8. Well Name and No.
OUTRIDER FEDERAL 6H9. API Well No.
30-025-4293210. Field and Pool, or Exploratory
WC-025 G-06 S253306M; BS11. County or Parish, and State
LEA COUNTY, NM

XTO Energy, Inc respectfully requests the following changes to the drilling program originally submitted with the APD:

**Outrider Federal 6H
30-025-42932
XTO Energy, Inc
Conditions of Approval**

DRILLING PLAN: BLM COMPLIANCE
(Supplement to BLM 3160-3)

Exhibit E-1 – Choke Manifold Diagram
 Outrider Federal #6H
 XTO Energy, Inc..

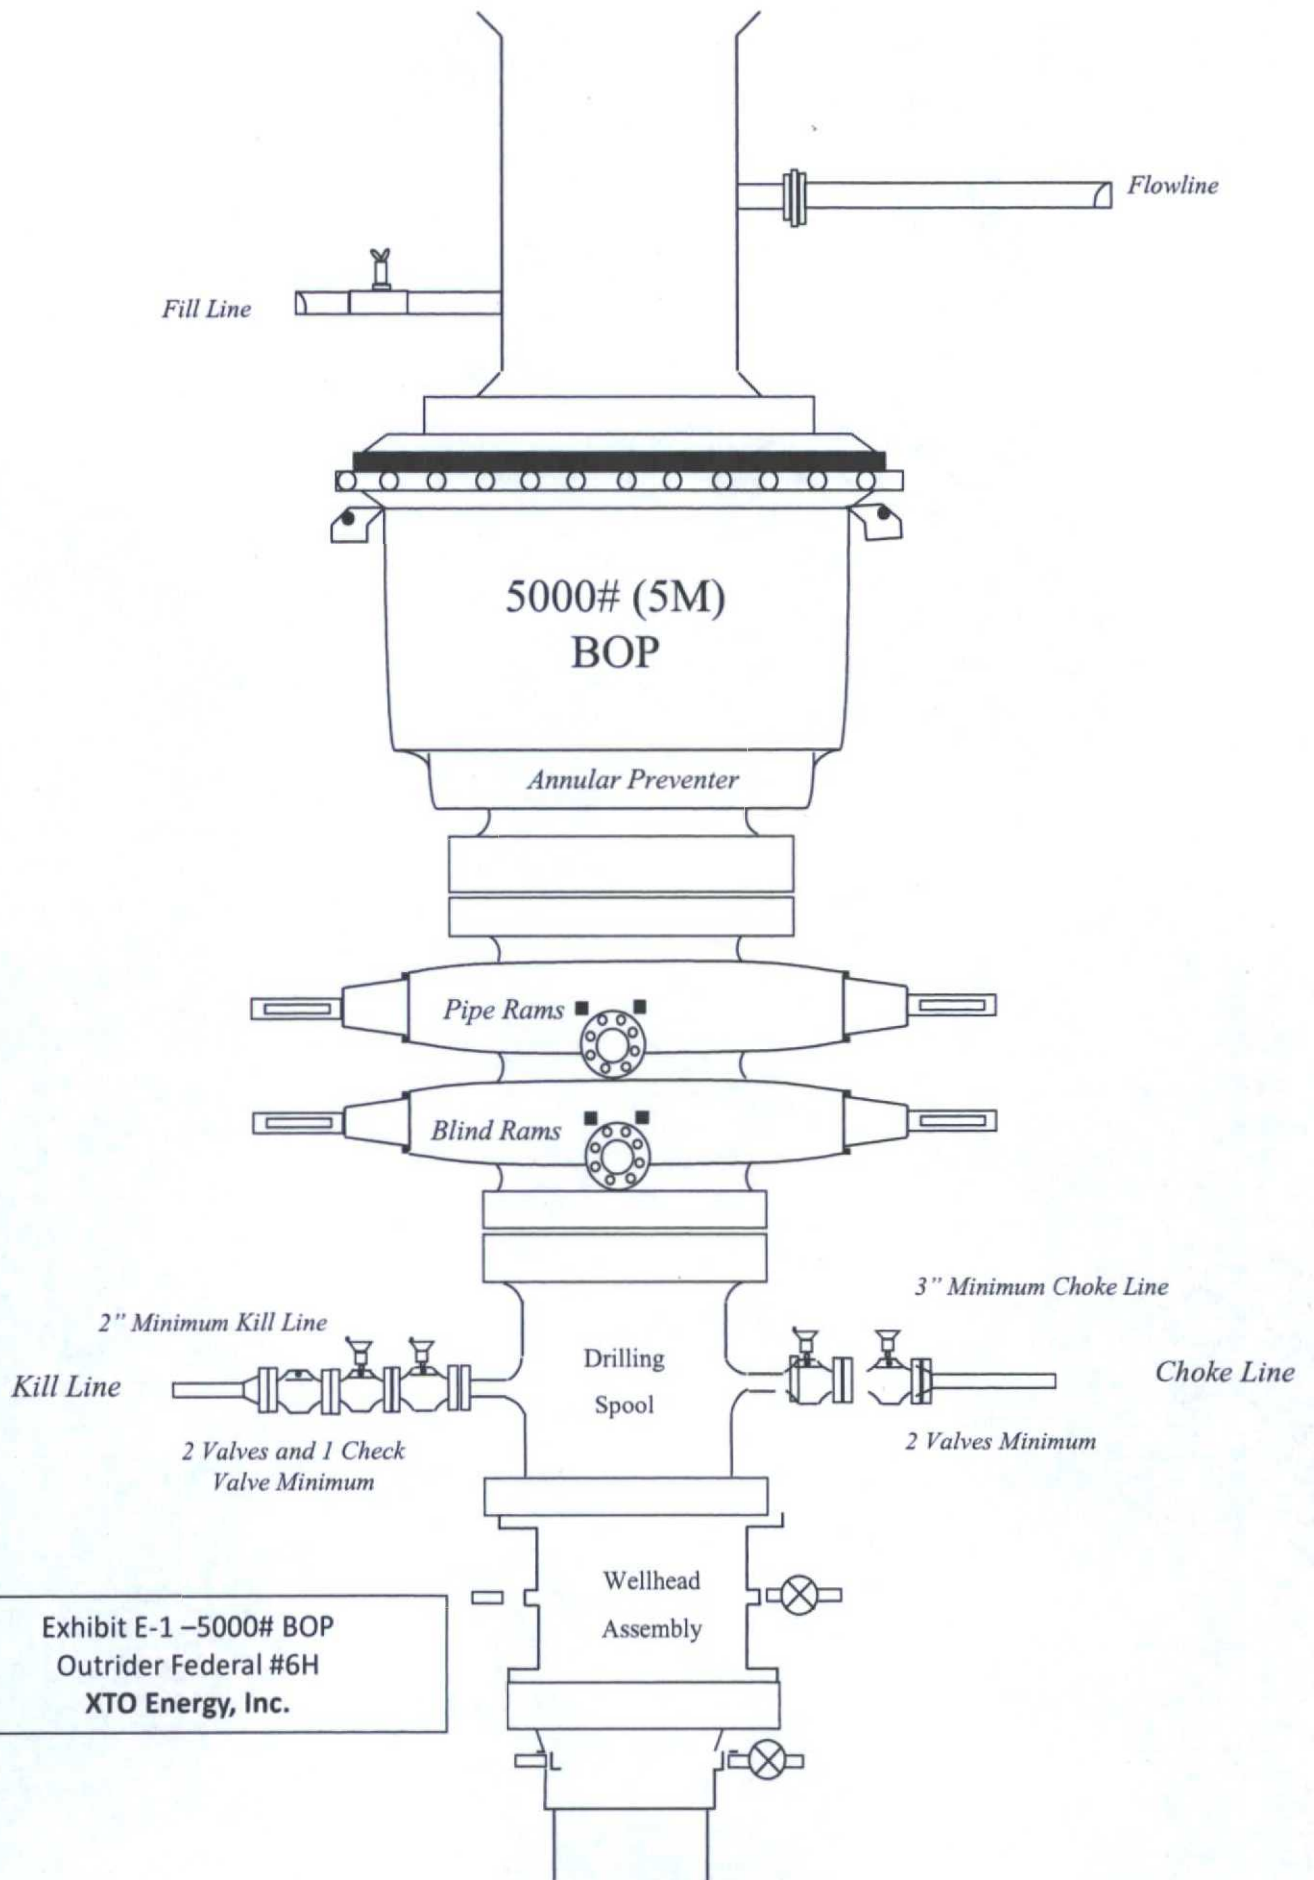
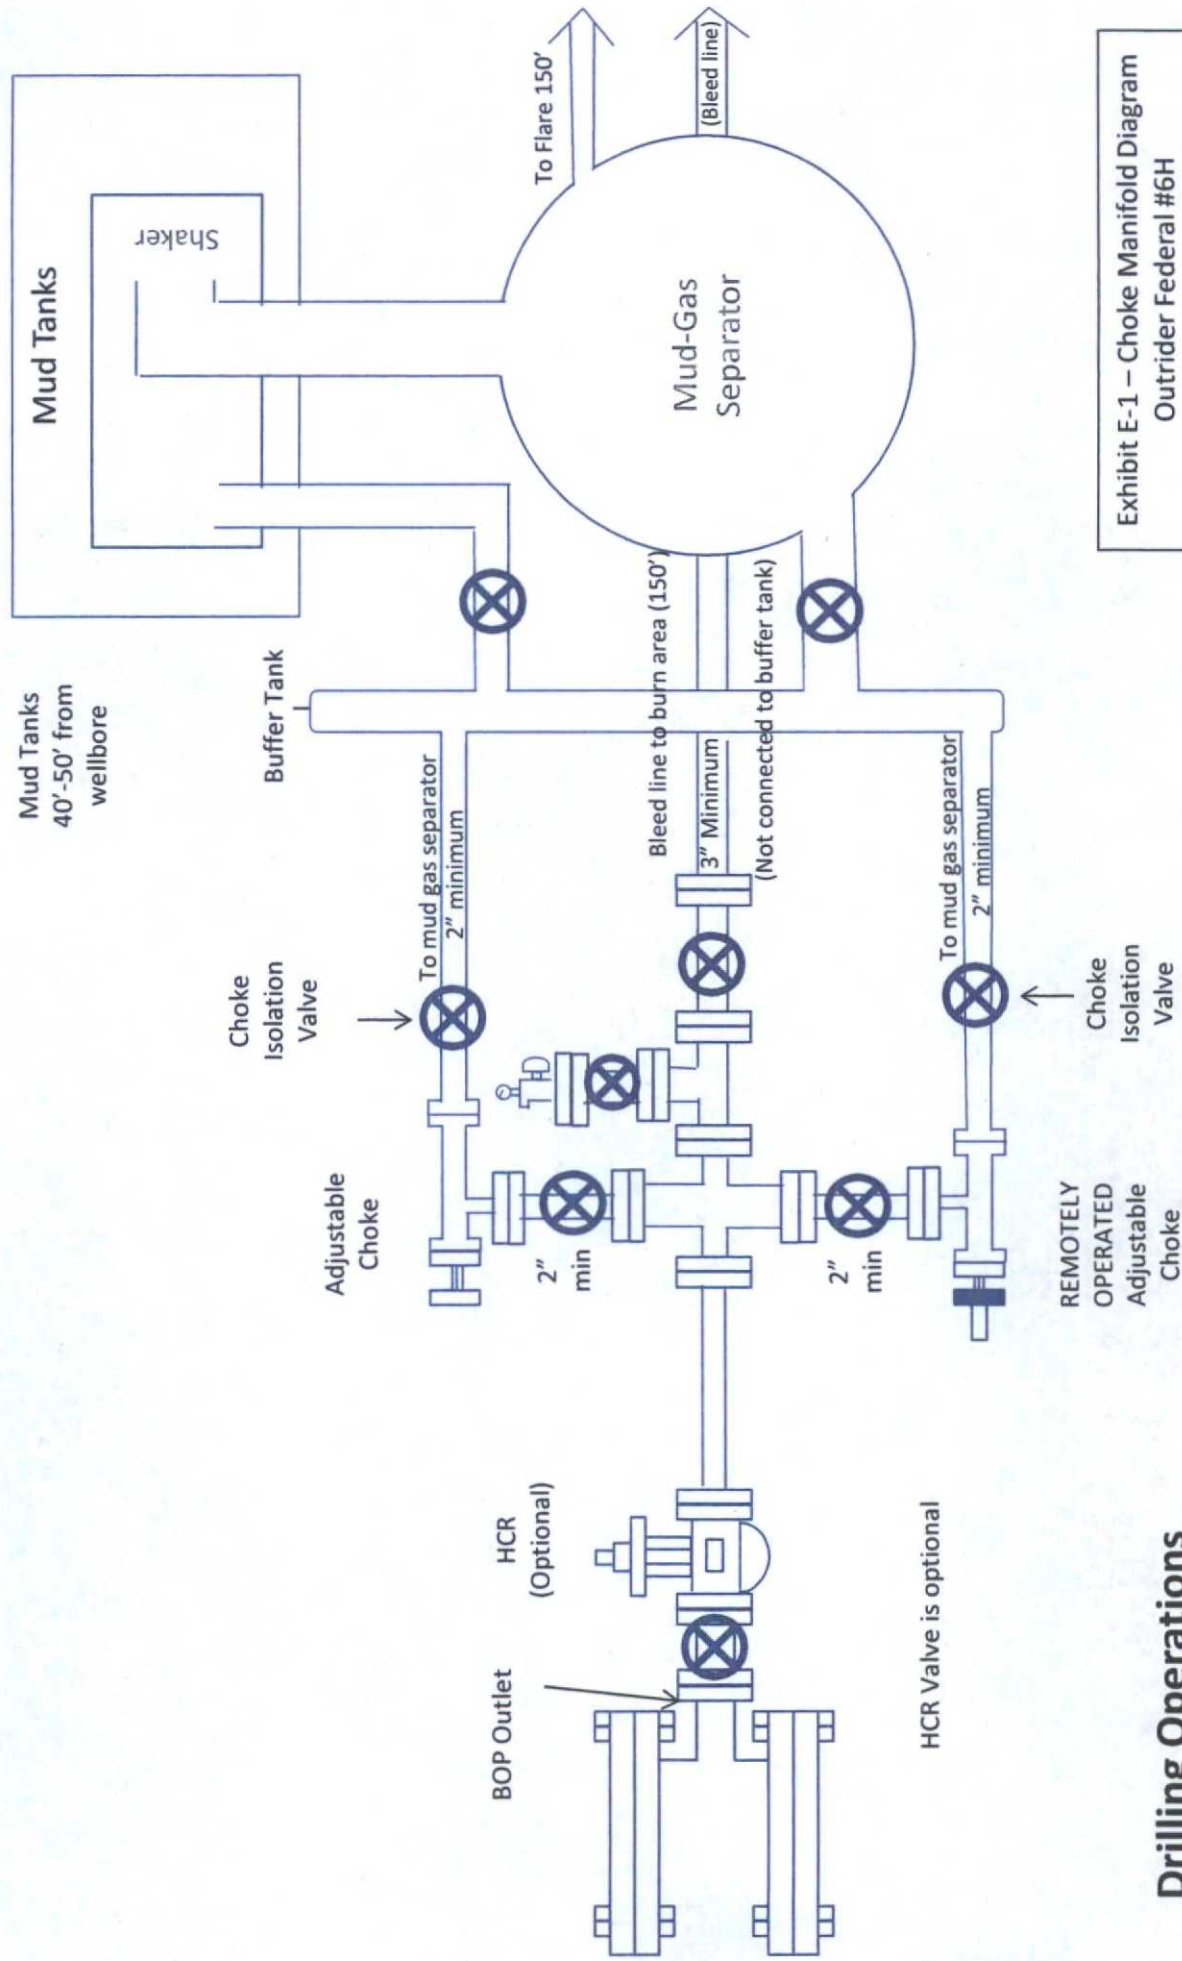
- Revised plug designs for the pilot hole (Section 4)
- 5M system below the intermediate casing (Section 5) – diagram attached
- Request to use centralizers only in the curve on the production casing string (Section 3)

A variance is requested to allow use of a flex hose as the choke line from the BOP to the Choke Manifold. If this hose is used, a copy of the manufacturer's certification and pressure test chart will be kept on the rig. Attached is an example of a certification and pressure test chart. The manufacturer does not require anchors.

C. PRESSURE CONTROL

1. All blowout preventer (BOP) and related equipment (BOPE) shall comply with well control requirements as described in Onshore Oil and Gas Order No. 2 and API 53.

2. Variance approved to use flex line from BOP to choke manifold. Check condition of flexible line from BOP to choke manifold, replace if exterior is damaged or if line fails test. Line to be as straight as possible with no hard bends and is to be anchored according to Manufacturer's requirements. The flexible hose can be exchanged with a hose of equal size and equal or greater pressure rating. Anchor requirements, specification sheet and hydrostatic pressure test certification matching the hose in service, to be onsite for review. These documents shall be posted in the company man's trailer and on the rig floor. If the BLM inspector questions the straightness of the hose, a BLM engineer will be contacted and will review in the field or via picture supplied by inspector to determine if changes are required (operator shall expect delays if this occurs).

3. Minimum working pressure of the blowout preventer (BOP) and related equipment (BOPE) required for drilling below the surface casing shoe shall be **5000 (5M) psi**.
